UNITED STATES
NUCLEAR REGULATORY COMMISSION
REGION IV
611 RYAN PLAZA DRIVE, SUITE 1000
ARLINGTON, TEXAS 76012

In Reply Refer To:
RIV
Docket No. 50-498
50-499

South Texas Project
Units 1 & 2
Final Report on the Safety
Injection System Piping Deficiency

SAFETY INJECTION SYSTEM PIPING DEFICIENCY May 30, 1980

FIGURE - 1

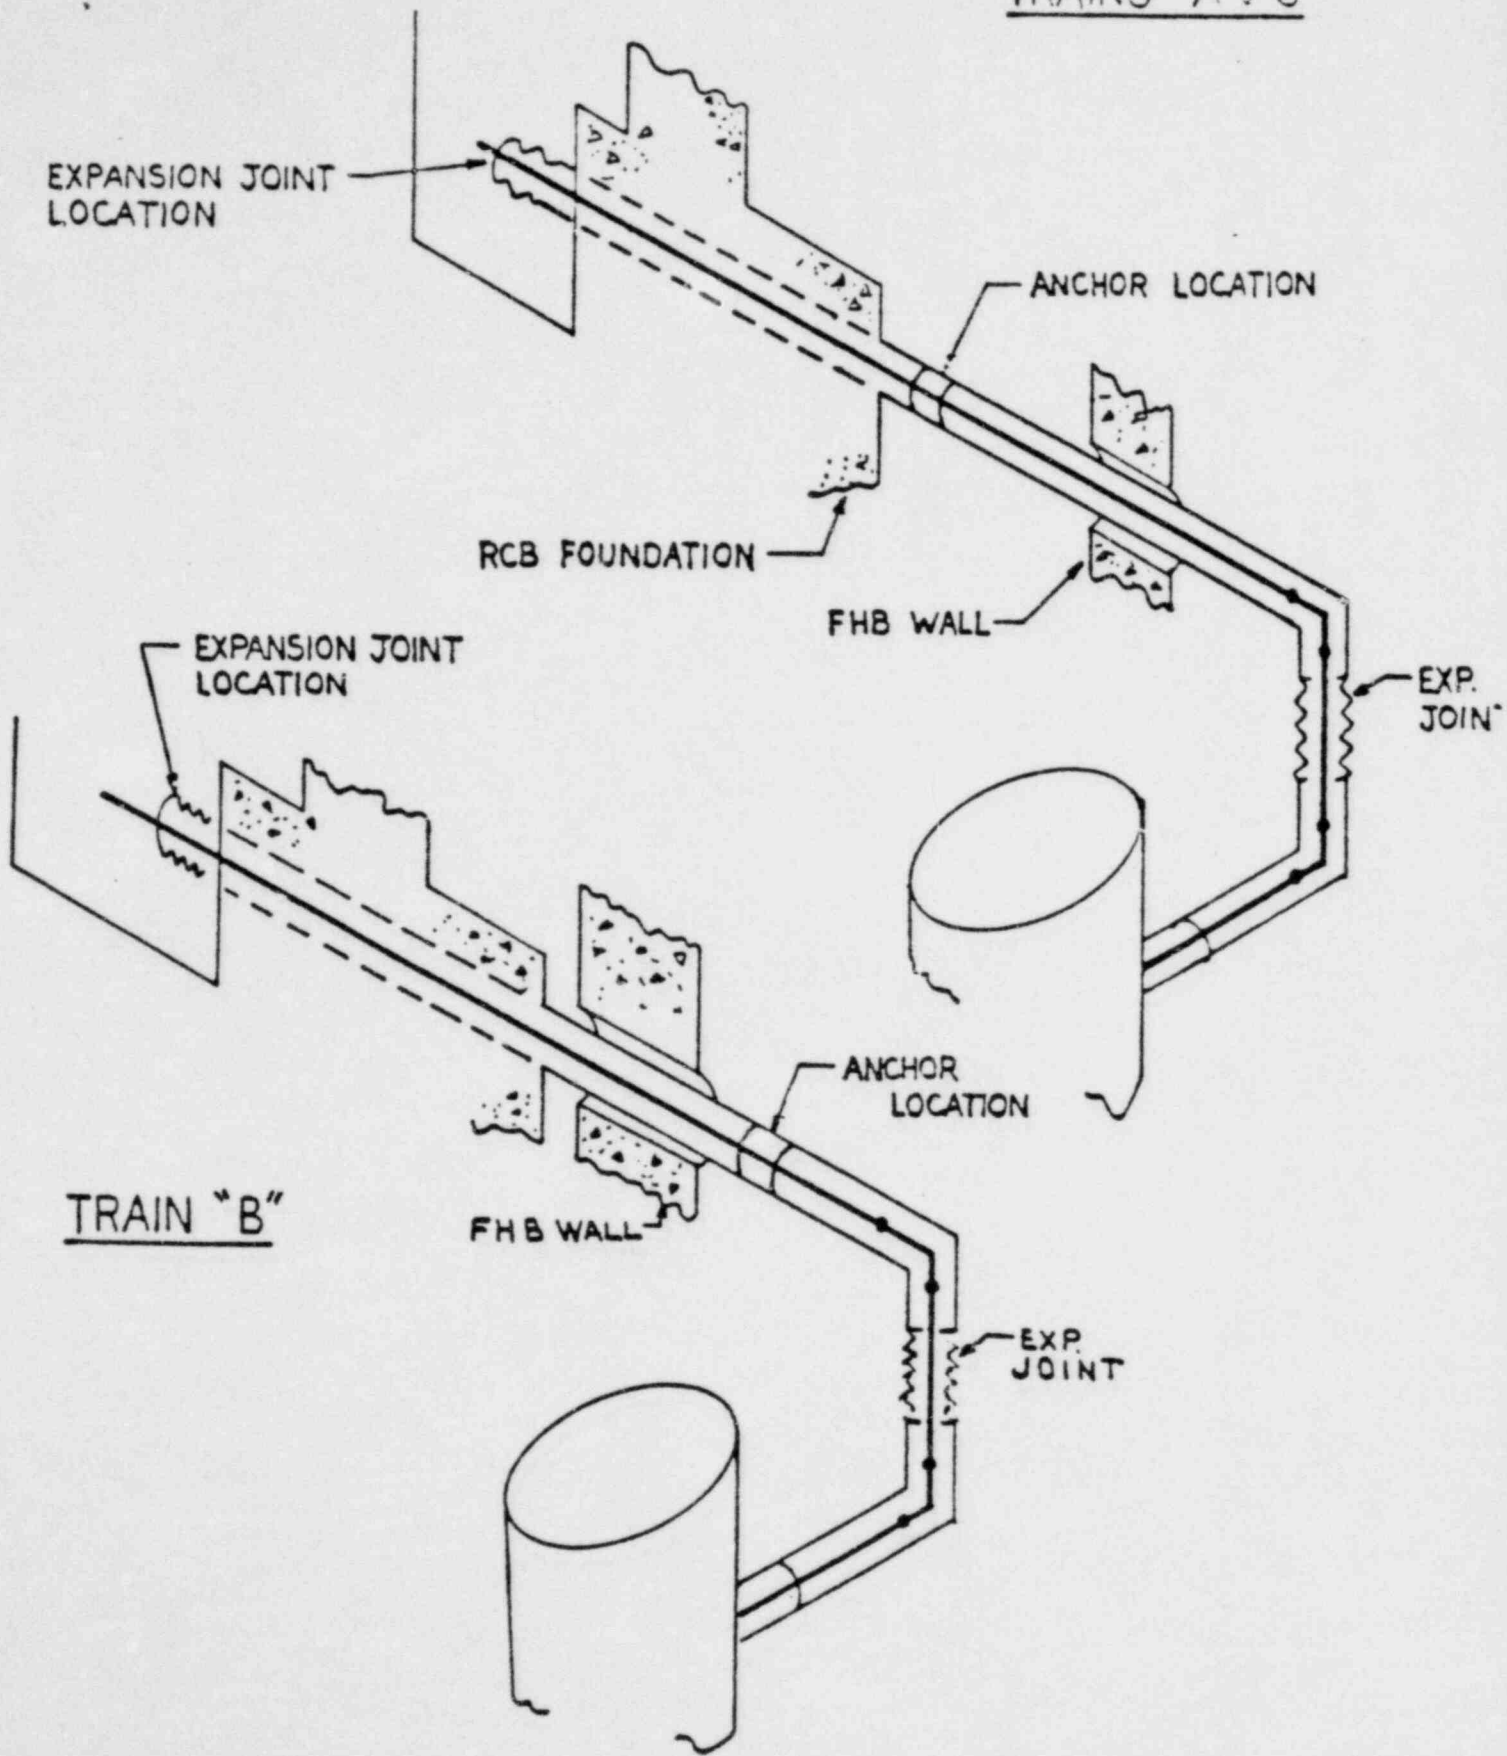
Thank you for your letter ST-HL-AE-472 of May 30, 1980, that transmitted your final report of a 50.55(e) item, "Safety Injection System Piping Deficiency." In review of your report, we find that additional information is required. Specifically, as discussed by Mr. Hubacek of this office with Messrs. Rodgers and Hernandez of your staff on July 9, 1980, clarification of penetration details as shown on Figure 1 of the subject report is required. The clarification should address disposition of the seal weld between the process pipe and the emergency sump liner.

This deficiency will be corrected by anchoring the process pipe to the guard pipe outside the containment building and adding an expansion joint to the process pipe inside the emergency sumps (see Figure 1).
